Rebuttal Proof of Evidence re MKC of Martin J Paddle BSc
CEng CWEM MICE FCIHT MCIWEM, in regard to Transport,
Highway and Accessibility Matters: PINS ref:
APP/Y0435/W/20/3252528 LPA ref: 15/00619/FUL

**OUR REF. NO. SWMK: REBUTTAL PROOF OF EVIDENCE RE MKC OF MARTIN J
PADDLE**

DATE: 27 APRIL 2021

Figure 5-3 - Junction 2: Buckingham Road/Shenley Road Mini-Roundabout Mitigation

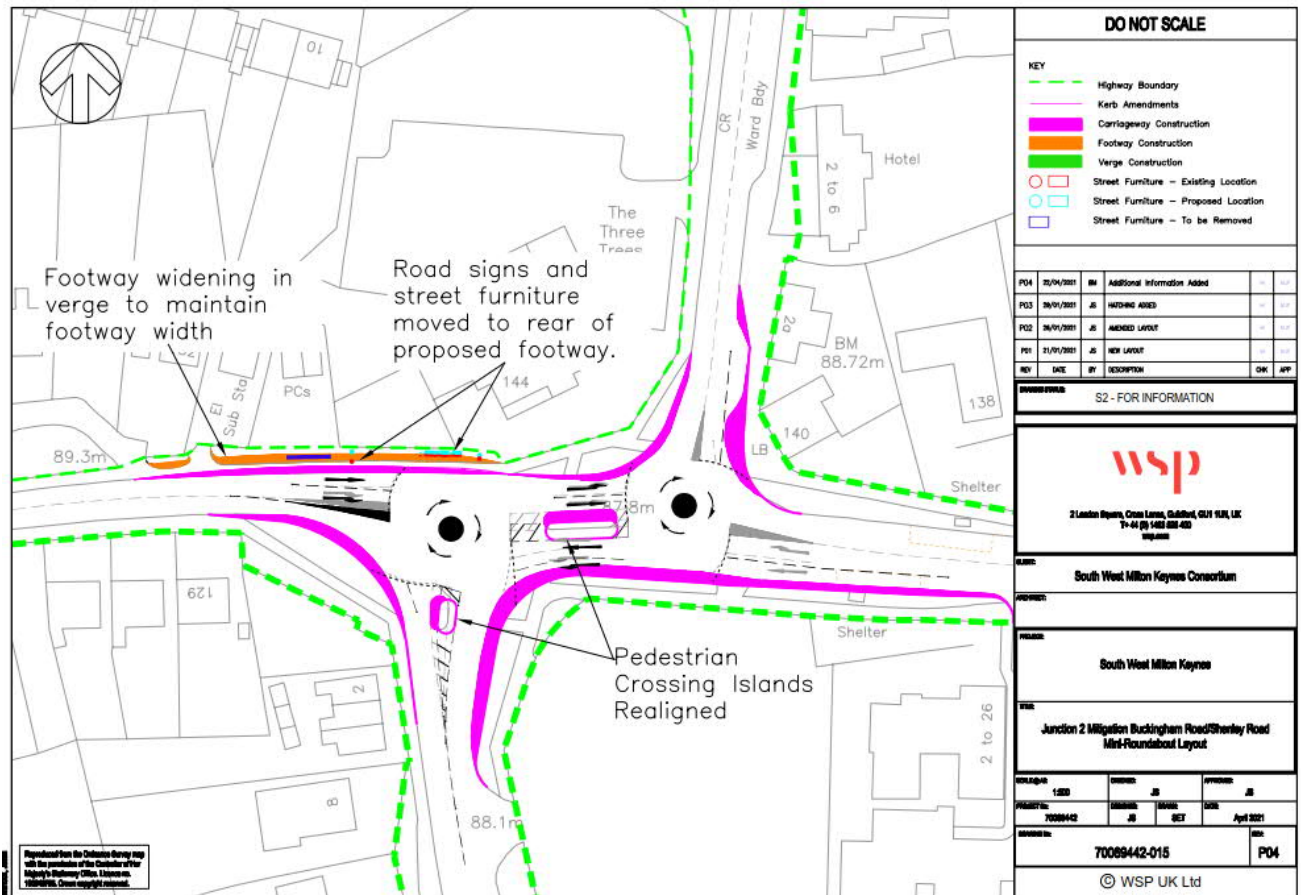
- 5.26 I refer to paragraphs 6.4.13 to 6.4.14 of Mr McKechnie's main Proof. It is not proposed to remove half of the footway width on the northern side of Buckingham Road. This would be addressed through the detailed design process (a stage of the S278 process). However, to address this point

for the purposes of the Inquiry we have provided additional detail on the plan below to show how the footway would be accommodated and street furniture relocated. This is shown in **Figure 5-3** and Appendix MJ34.

- 5.28 With reference to paragraph 6.4.16 of Mr McKechnie's main Proof, the pedestrian refuge islands and crossing points would be retained and this has been clarified on the updated version of the drawing (Figure 8).

Figure 5-4 - Forward Visibility to J5 Tattenhoe Roundabout

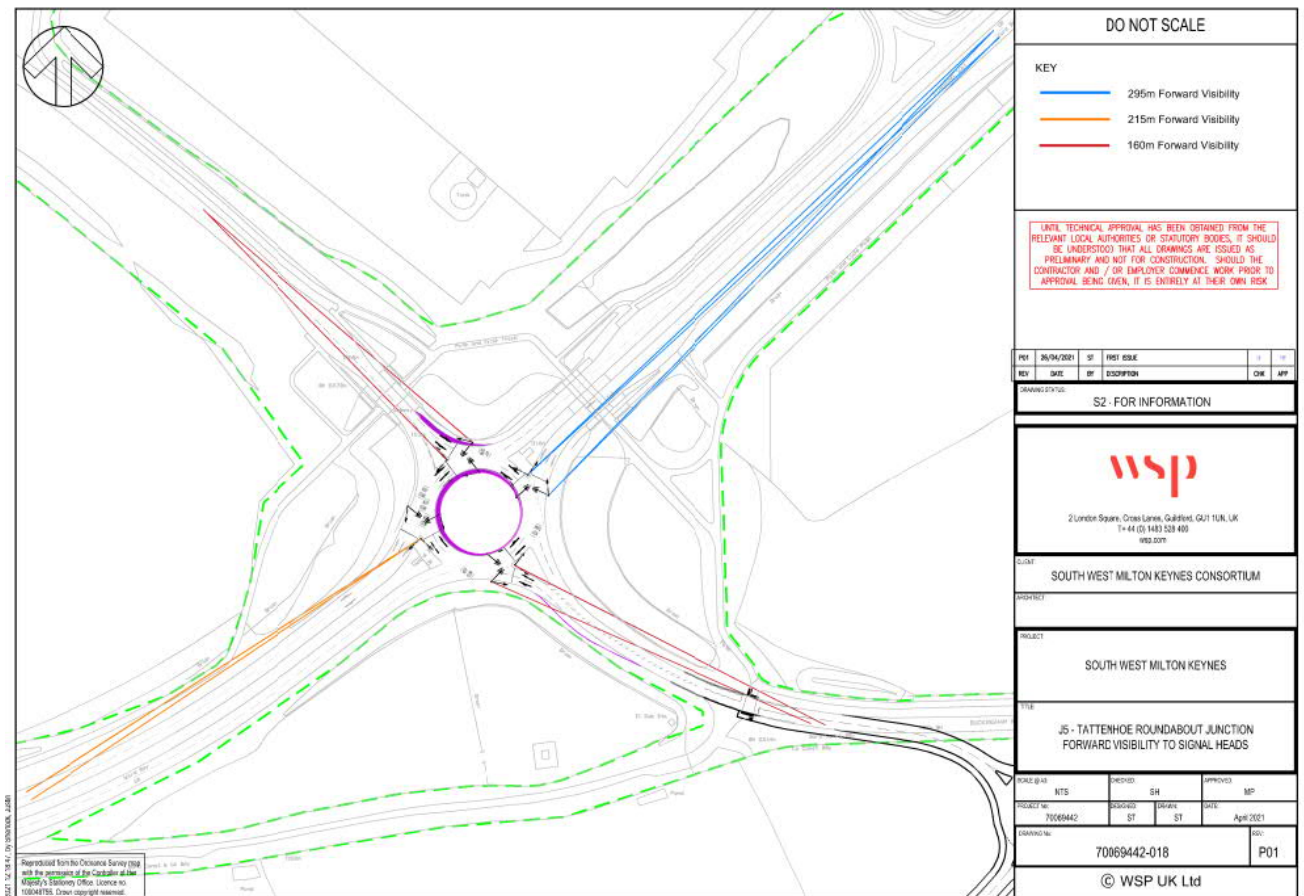
5.36 With reference to paragraphs 6.4.27 to 6.4.28 of Mr McKechnie’s main Proof, the desirable minimum stopping sight distance on the A421 approaches is in fact 215m on the eastbound approach and 295m on the westbound approach. As the roundabout is existing, the level of forward visibility to the junction itself would also need to meet this requirement at present. MKC must therefore have already accepted that the levels of forward visibility to the junction are sufficient otherwise it would be expected that additional warning would be provided on the approaches, which it is not. On Buckingham Road, the presence of the site access roundabout will significantly reduce vehicle speeds on this approach and therefore suitable levels of forward visibility can be achieved (**Figure 5-4** and MJP35).

Figure 5-5 - Junction 5: Tattenhoe Roundabout Mitigation Layout

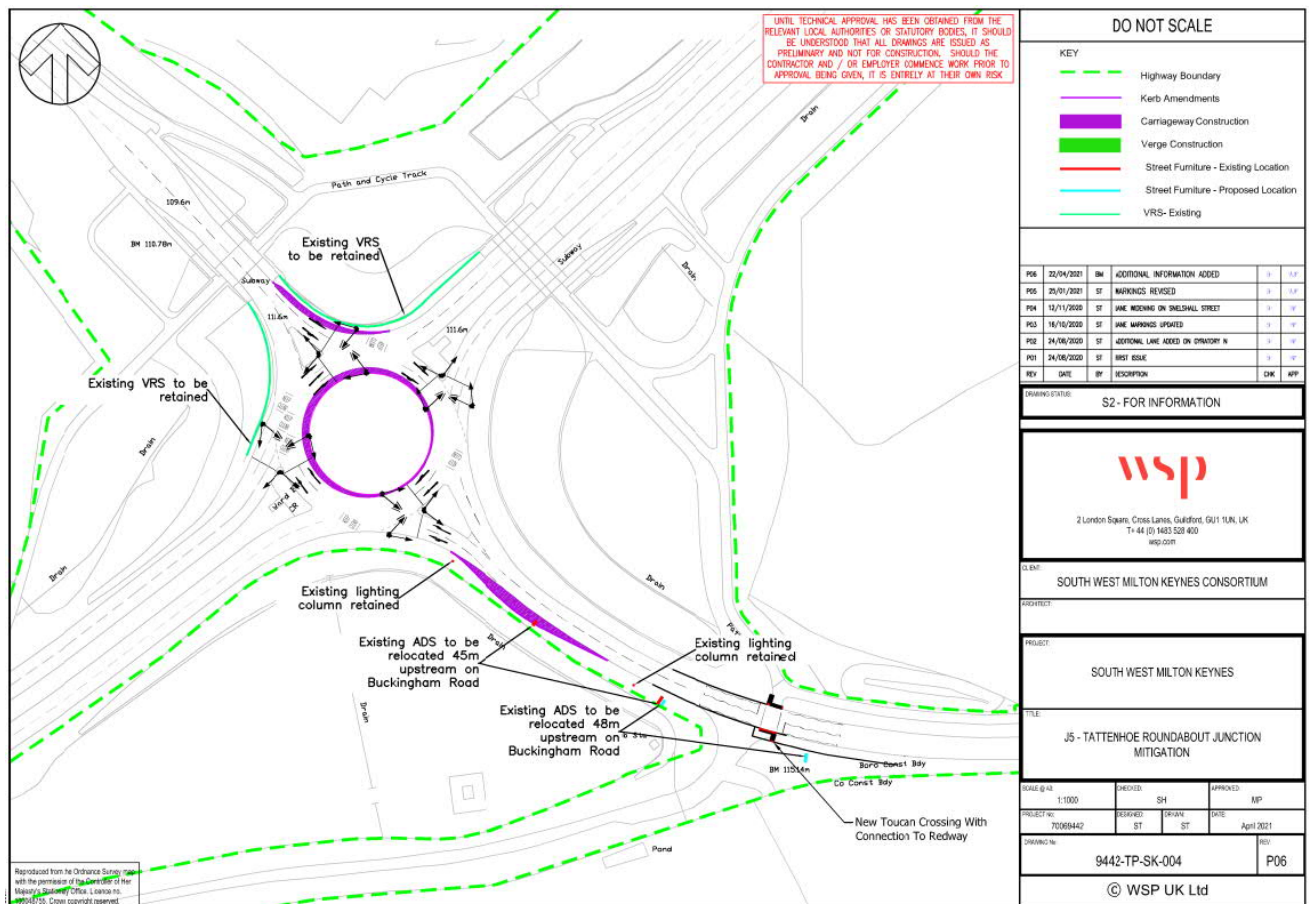
5.40 With reference to paragraph 6.4.32 and 6.4.33 of Mr McKechnie’s main Proof, I do not consider that any further assessment is required to determine that the proposed mitigation is deliverable, however, notwithstanding, additional detail is provided on the layout plan (with no changes to the proposed mitigation itself) to identify the existing street furniture with an option for where, if necessary, it could be relocated. This is presented in Figure 5-5 and Appendix MJP36. **Figure 5-5** demonstrates that not only have some items of street furniture been erroneously highlighted by Mr McKechnie as an issue but that simple measures can be taken to address the other points of concern.

Figure 5-6 - Junction 12: Kingsmead Roundabout Mitigation Layout

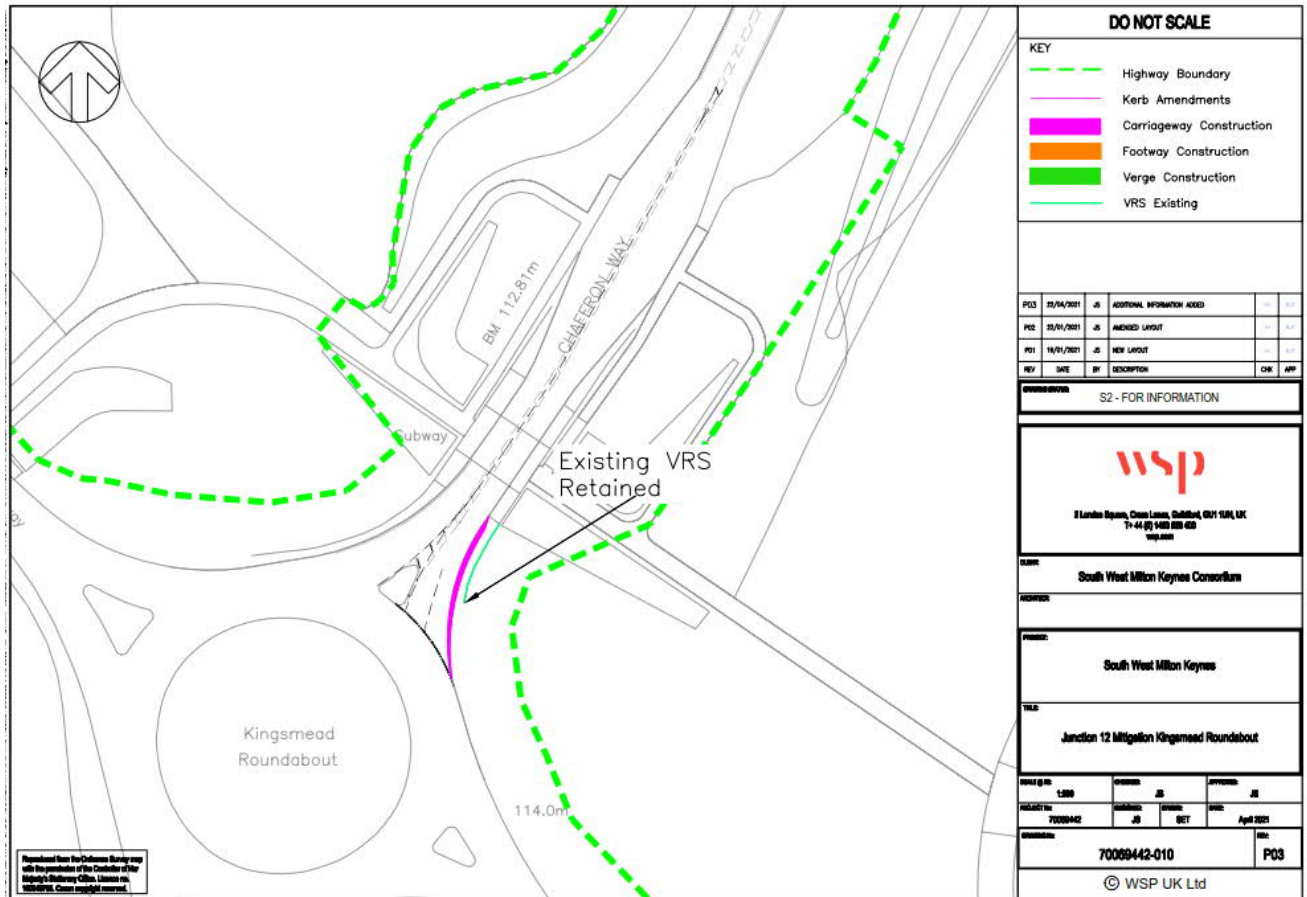
- 5.46 I refer to paragraph 6.4.51 of Mr McKechnie's main Proof which implies that the Vehicle Restraint System (VRS) may need to be relocated to accommodate the mitigation proposals. This is incorrect and a 1.2m setback from the amended carriageway edge can still be achieved to the VRS. This is illustrated in **Figure 5-6** and appendix MJP38.

Figure 5-7 - Junction 14: Furzton Roundabout Mitigation Layout

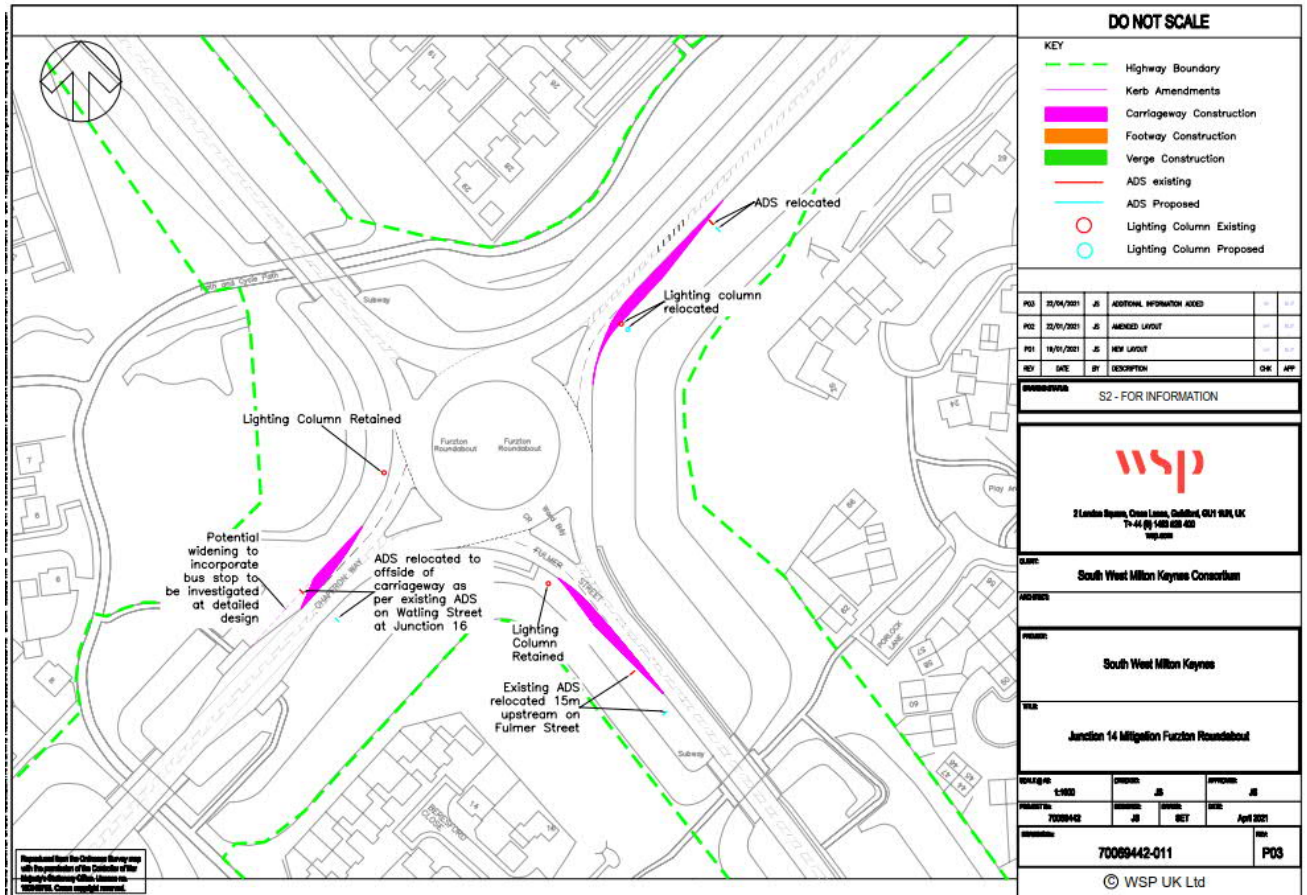
5.48 I refer to paragraph 6.4.54 of Mr McKechnie’s main Proof which implies that street furniture would need to be relocated to accommodate the mitigation proposals. There is no issue with the relocation of street furniture within the highway boundary, however a supplementary layout plan (with no change to the mitigation scheme itself) has been produced to demonstrate how the existing street furniture would be relocated and accommodated within the proposals. This supplementary detail is shown in **Figure 5-7** and Appendix MJP40

Figure 5-8 - Junction 15: Bleak Hall Roundabout Mitigation Layout

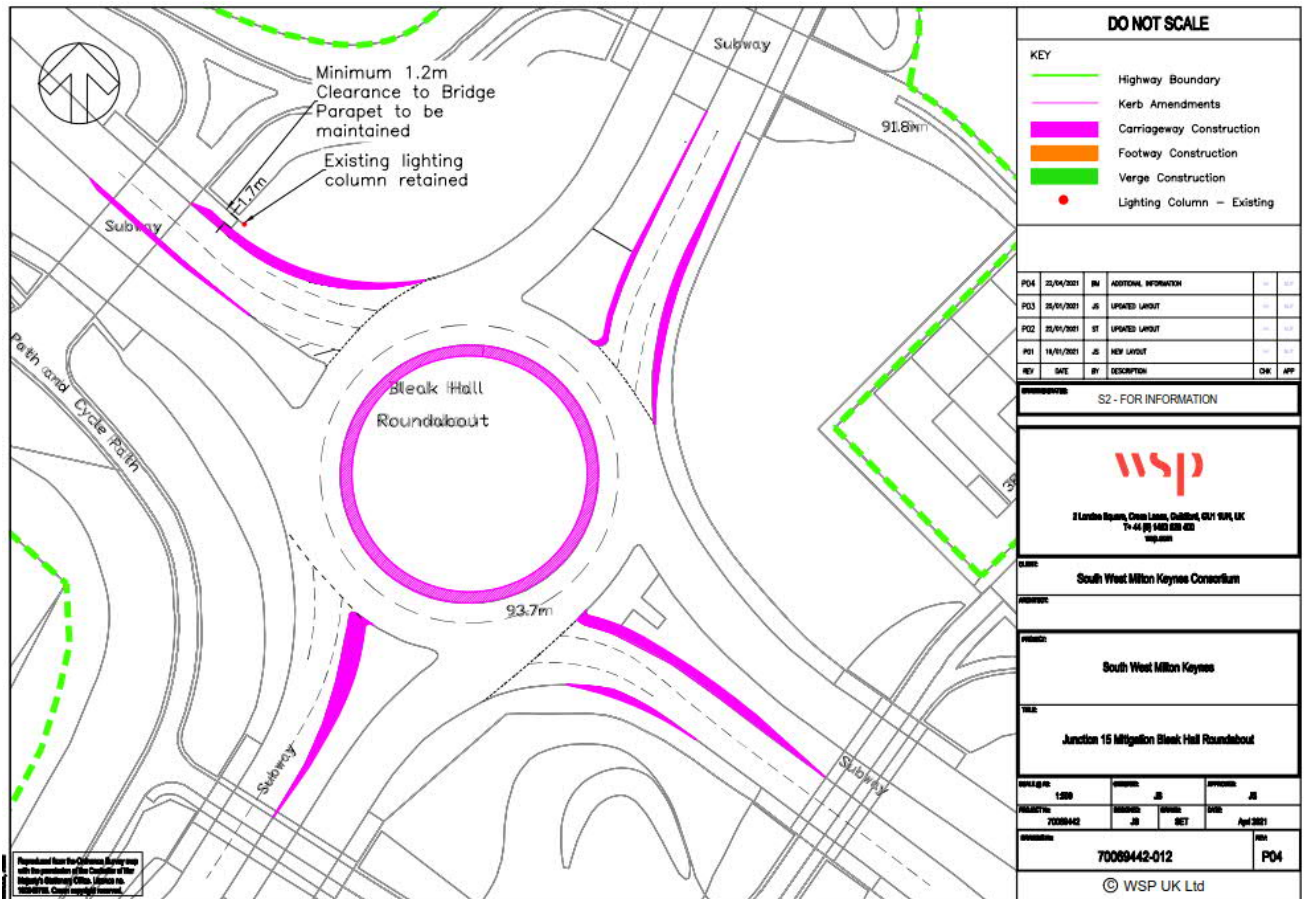
- 5.51 With regard to paragraphs 6.4.60 and 6.4.61 of Mr McKechnie’s main Proof in relation to entry angles and entry path curvature. The existing roundabout is not currently designed in accordance with DMRB and only minor modifications are proposed. The mitigation proposals have been the subject of Road Safety Audit (RSA) and a Designer’s Response was produced that agrees that the proposals are acceptable and safe.
- 5.52 With reference to paragraph 6.4.62 of Mr McKechnie’s main Proof, the offset from the amended kerb line to the bridge parapet and lighting column has been reviewed. An offset of 1.7m is still achievable as illustrated on the layout below showing additional detail in **Figure 5-8** and Appendix MJP41. There is no issue with the deliverability of the proposed mitigation.

Figure 5-9 - Junction 15: Bleak Hall Roundabout PM Peak Maximum Queue Lengths

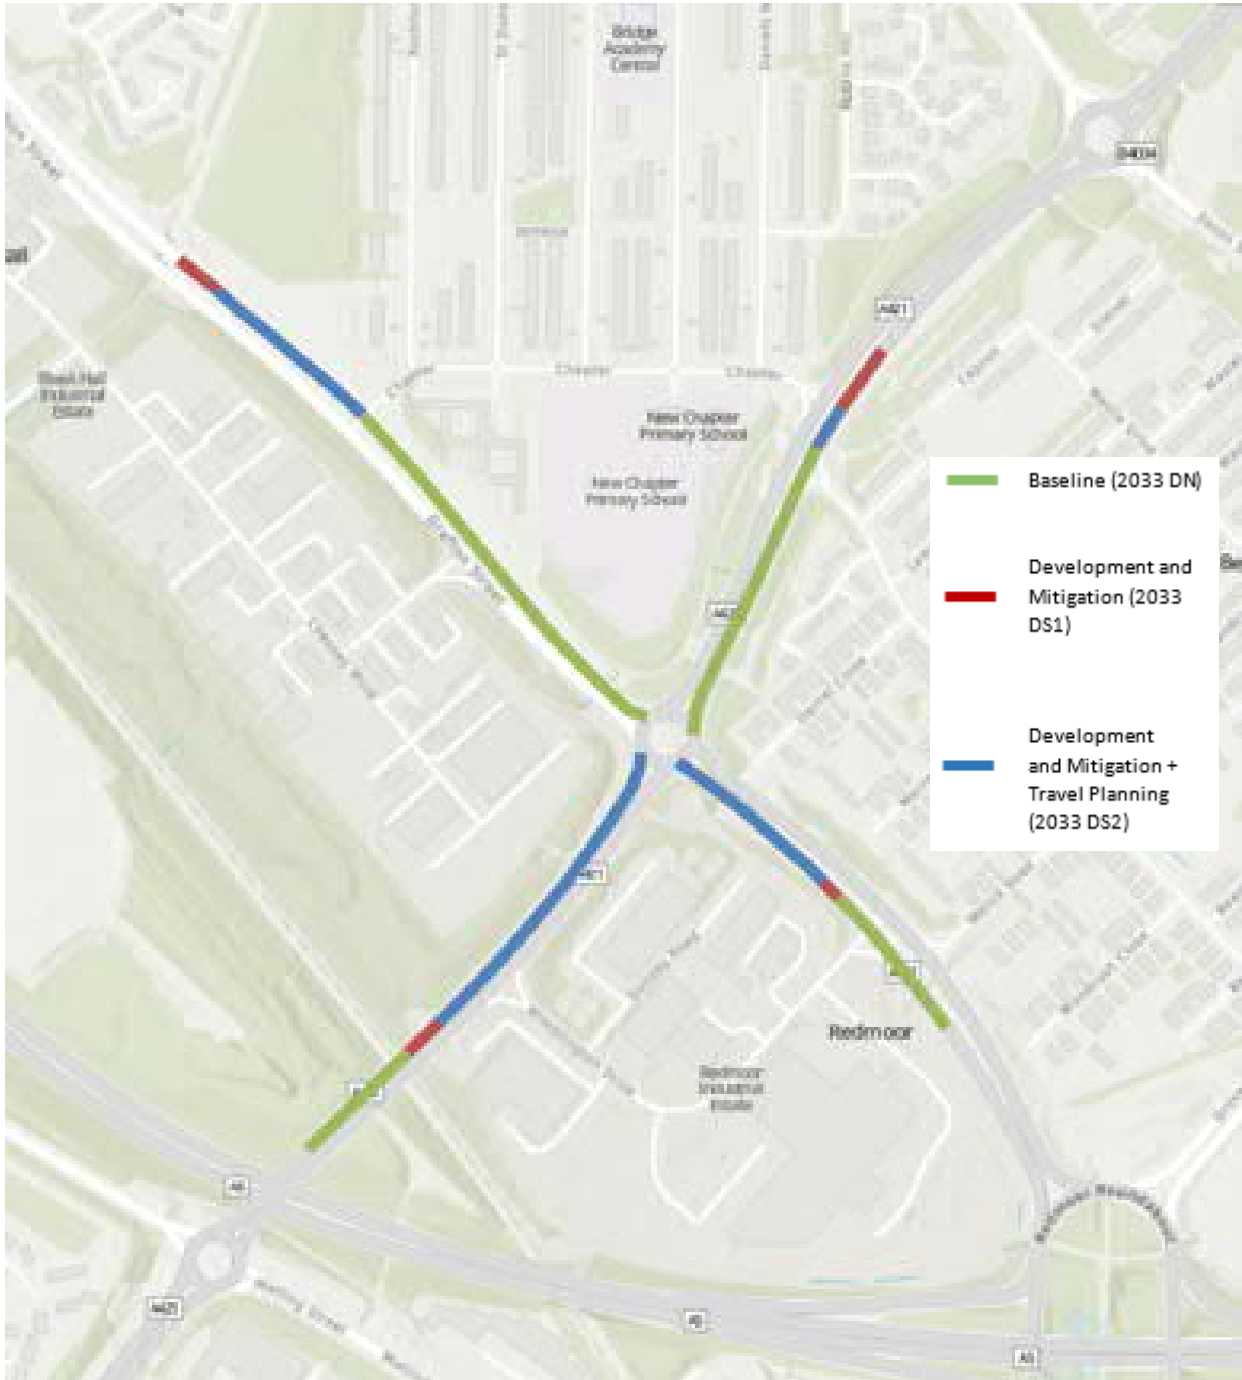
- 5.54 Furthermore, I disagree with his analysis. My team has undertaken a review of peak hour queue lengths. Figure 6-9 of this Rebuttal Evidence provides a summary of the queue lengths anticipated at J15 in the PM peak hour. Our analysis reaches different conclusions to that presented by Mr McKechnie and it is questioned how the queue lengths shown in Figure 6.8 were derived as there is no explanation of the methodology used.

5.56 **Figure 5-9** demonstrates that there would be no interaction between J15 and Coffee Hall Roundabout to the northeast, to J16 Elfield Park to the southwest, nor to A5 Redmoor Roundabout to the southeast, with significantly shorter queues than suggested in Figure 6.8 of Mr McKechnie’s main Proof. Furthermore, **Figure 5-9** demonstrates the reduction in the queue on the A421
